SIM 34 02 24

RECALL 24V-697: INTEGRATED BRAKE SERVOMOTOR

This Service Information Bulletin (Revision 4) replaces SI M34 02 24 **dated February 2025**.

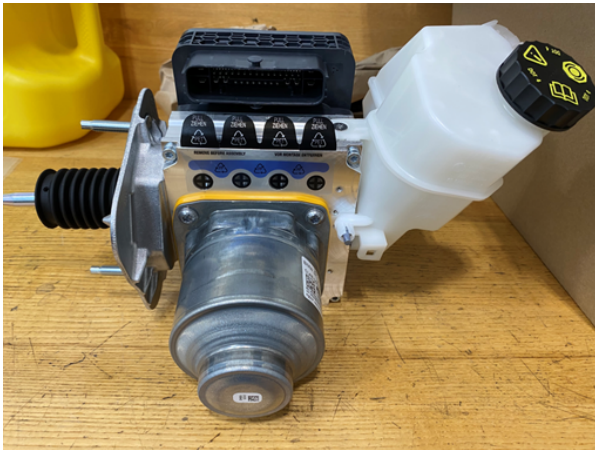
A quality inspection has shown that a weld seam on the servomotor of the IB was improperly made.

Replace the IB with either a "wet" pre-filled unit or a "dry" unfilled unit.

"Wet" IB pre-filled: Brake fluid reservoir is filled (arrow) and the four brake fluid line ports are plugged with bolts (circled).

Part number:
5B67B85
